Phil Bouchard
Shadow Mountain Bike Park

Re: First Referral Response Letter –Shadow Mountain Bike Park ODP
Case No. 23-102980 RZ

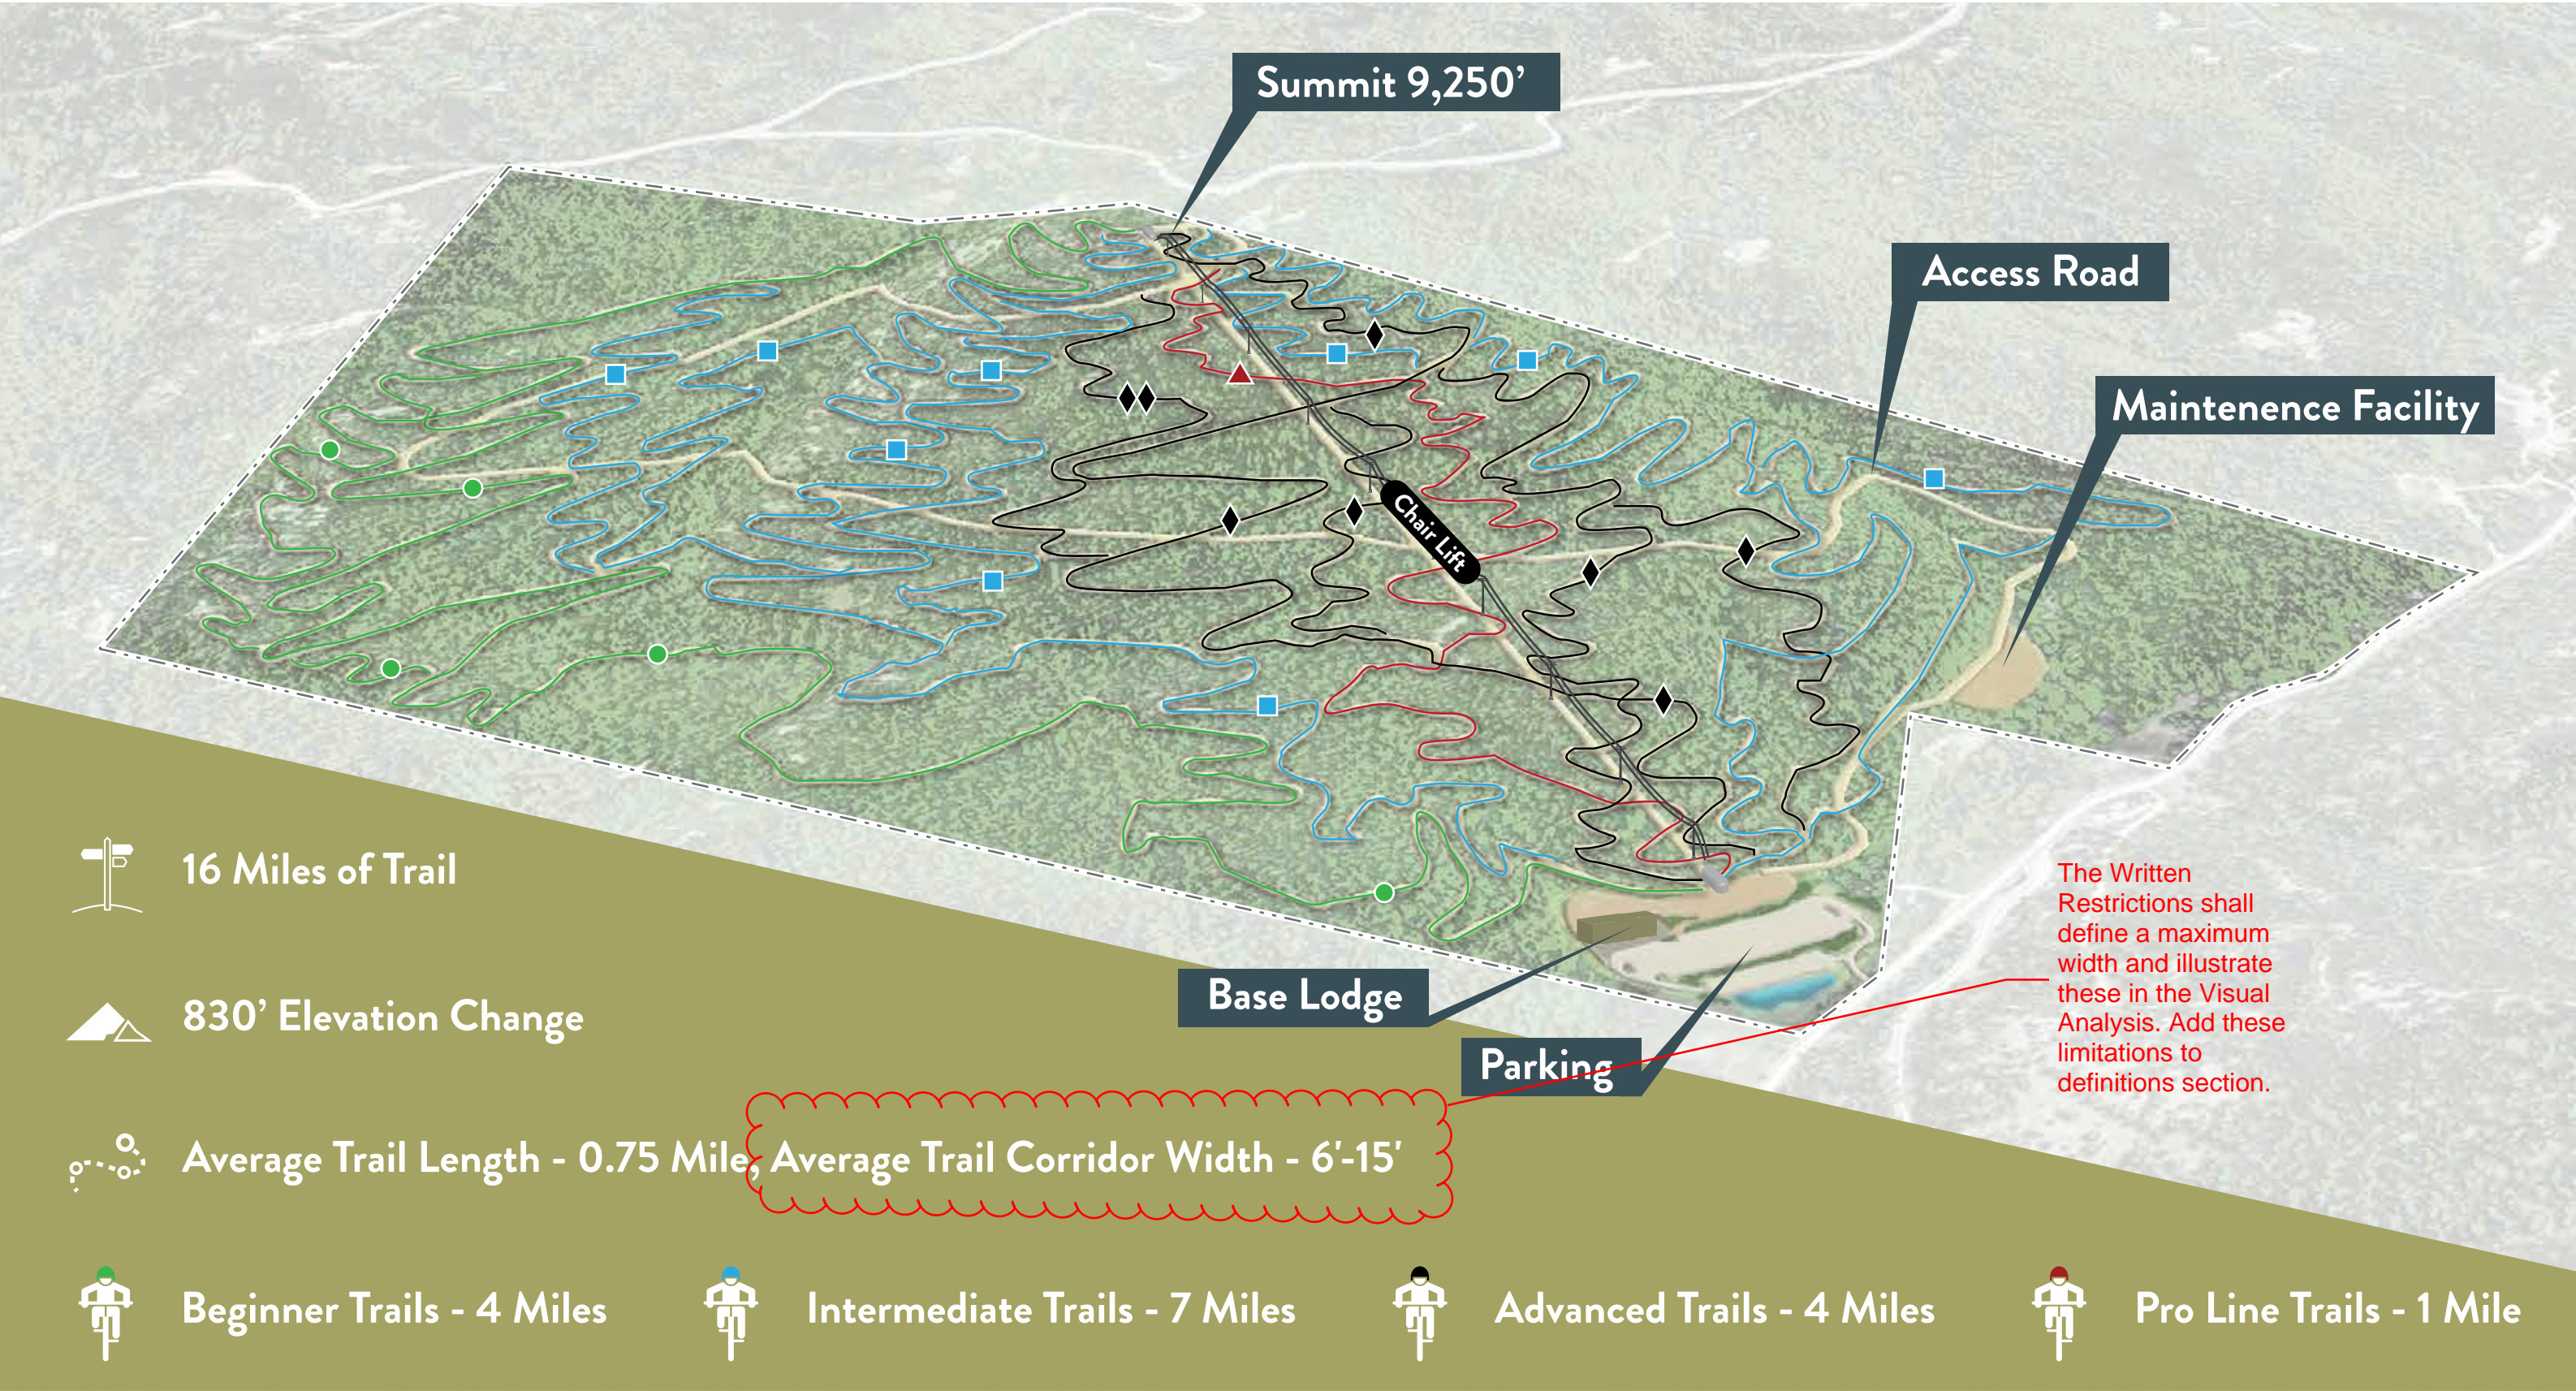
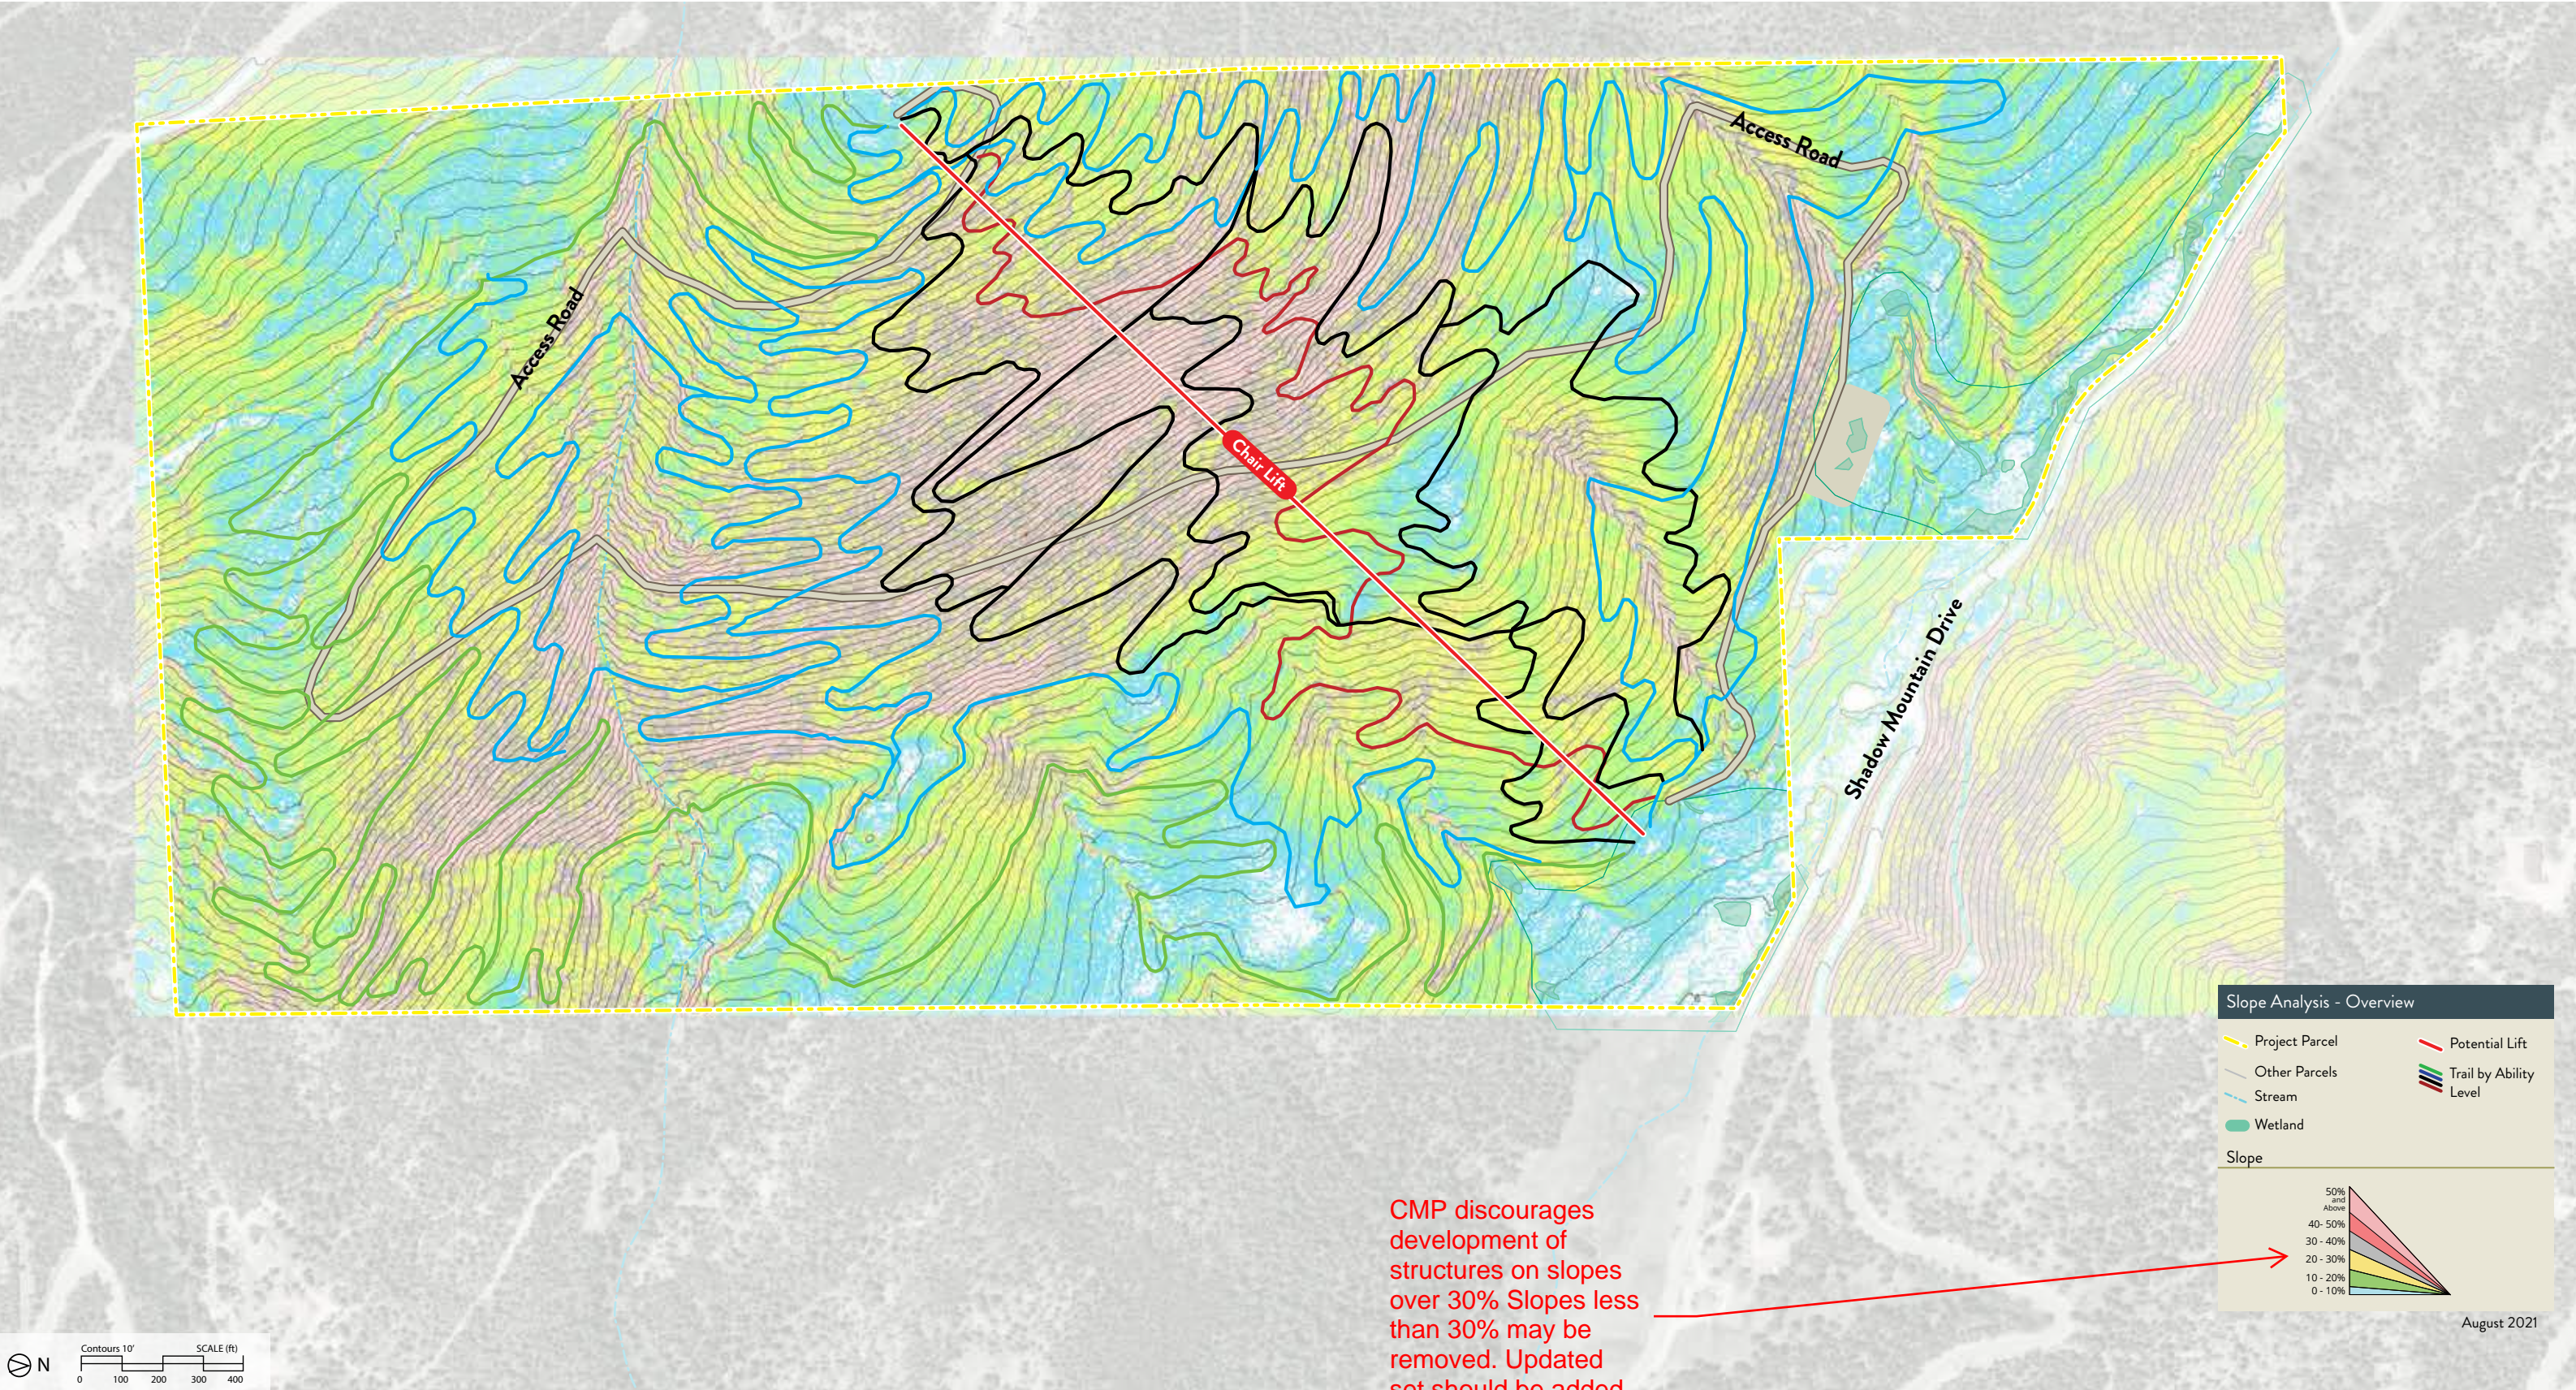
Strike this page

Strike this page

Strike this page

Strike this page

Strike this page

Strike this page
